SUBJECT: SYSTEMATIC EVALUATION PROGRAM (SEP) FOR THE LACROSSE
BOILING WATER REACTOR - EVALUATION REPORT ON TOPICS
VI-2.D AND VI-3

SAFETY EVALUATION REPORT
ON
CONTAINMENT PRESSURE AND
HEAT REMOVAL CAPABILITY
SEP TOPIC VI-3
AND
MASS AND ENERGY RELEASE
FOR POSSIBLE PIPE BREAK
INSIDE CONTAINMENT,
SEP TOPIC VI-2.D
FOR THE
LACROSSE NUCLEAR POWER PLANT

SEP Containment Analysis and Evaluation
for the La Crosse Nuclear Power Plant

Figure 7. Containment Pressure Response to a
0.634 sq. ft. Main Steam Line Break

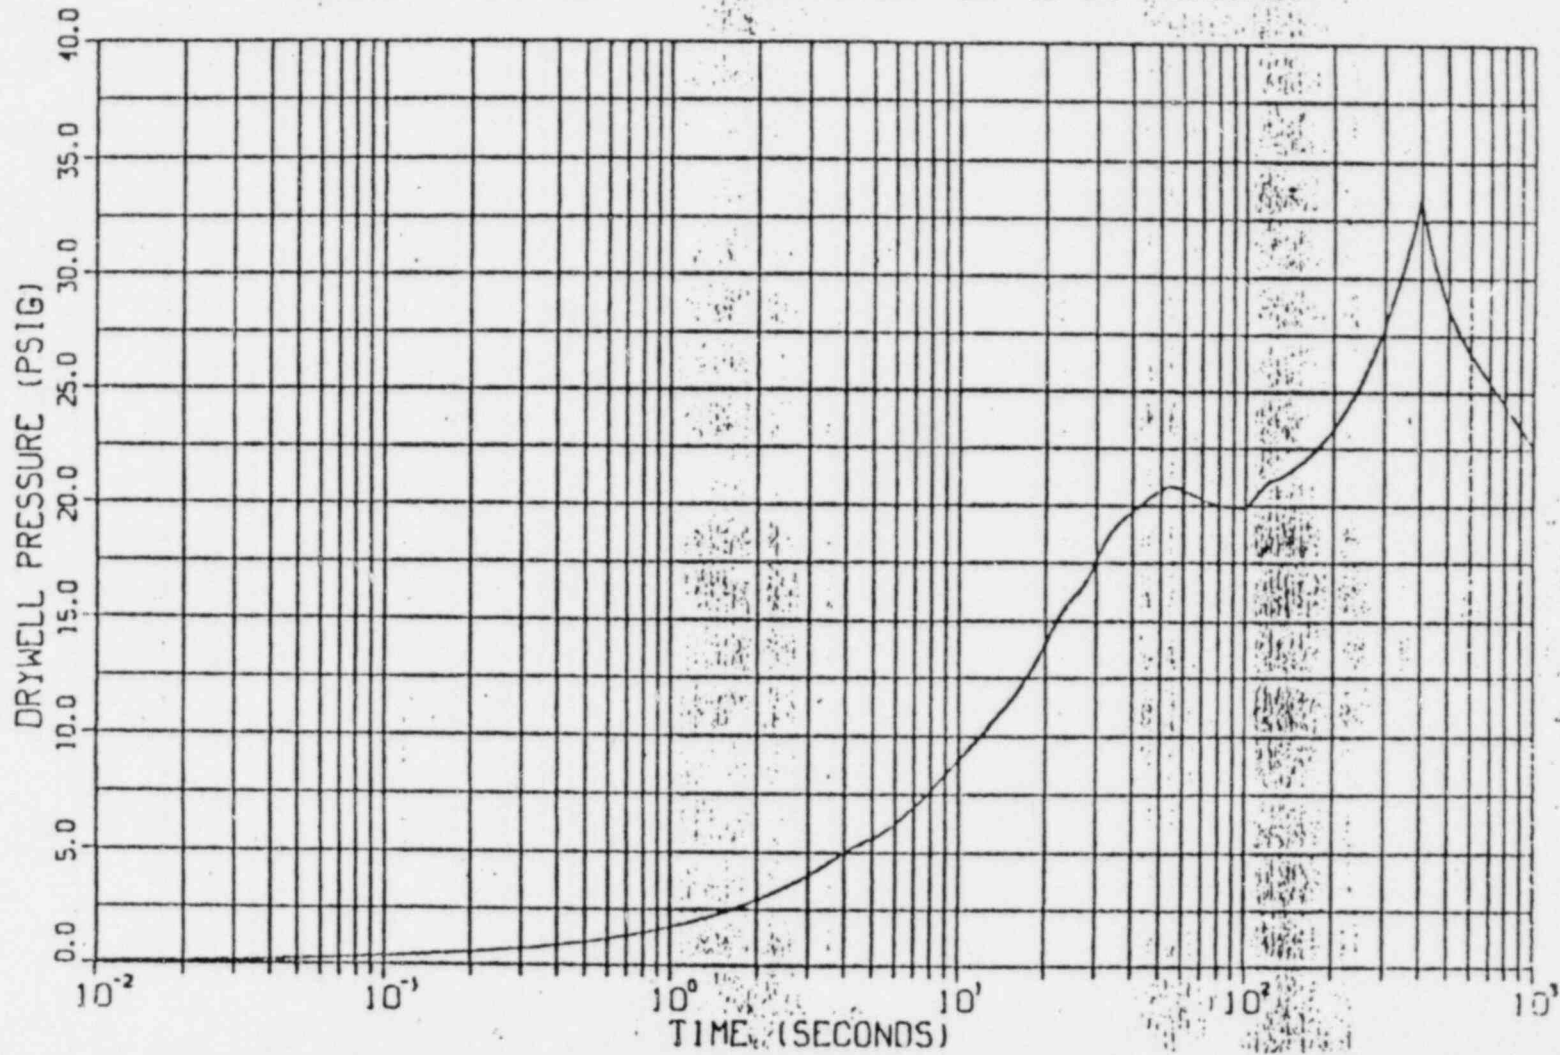
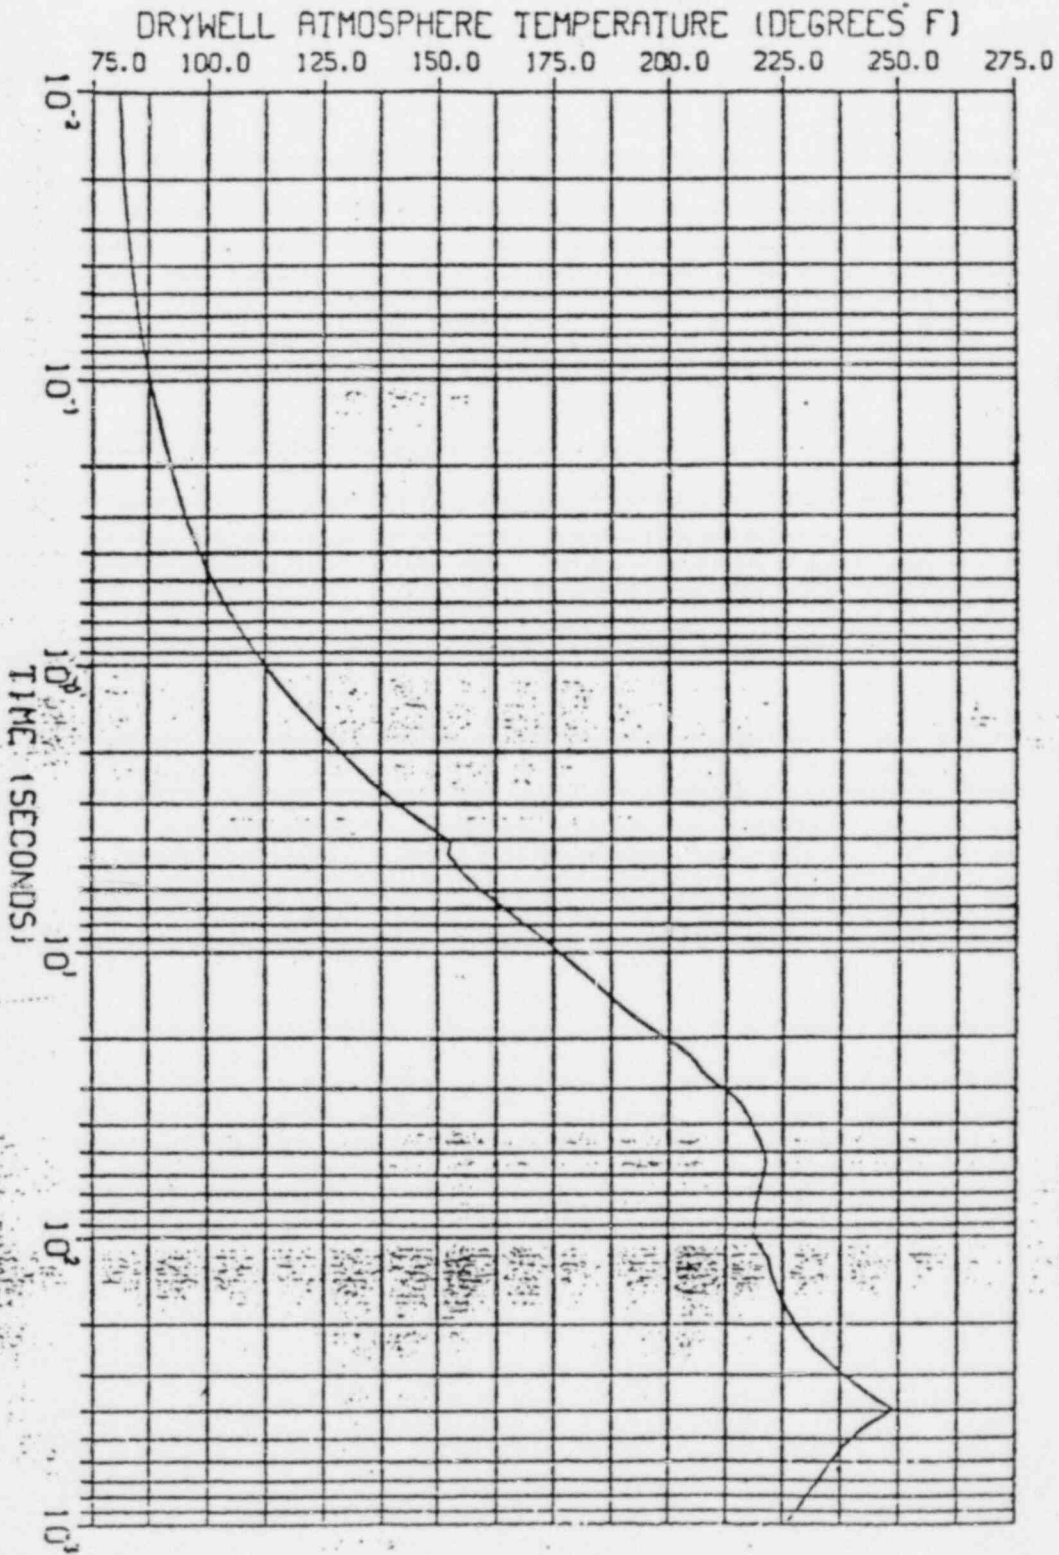
The response to a 0.1 ft² steam line break are shown in Figures 5 and 6. The calculated transient in this case reflects a peak post accident containment pressure of 21 psig and a temperature of 220°F. The response to the 0.634 ft² break is shown in Figures 7 and 8. This represents a double ended break of the eight inch steam line. The calculated transient reflects a peak post accident pressure of 33 psig and a temperature of 250°F. Neither the 0.10 ft² nor the 0.634 ft² break require operator action due to the fact that these larger break sizes cause the primary system to depressurize in a much faster time frame than the smaller 0.01 ft² break.

Assuming operator action as discussed above for the 0.01 ft² break, the peak containment pressures are substantially below the design value of 52 psig for all three cases. The post accident temperature for the 0.634 ft² steam line break results in the most severe temperature conditions for a main steam line break but is still less than 265°F resulting from a recirculation line break.
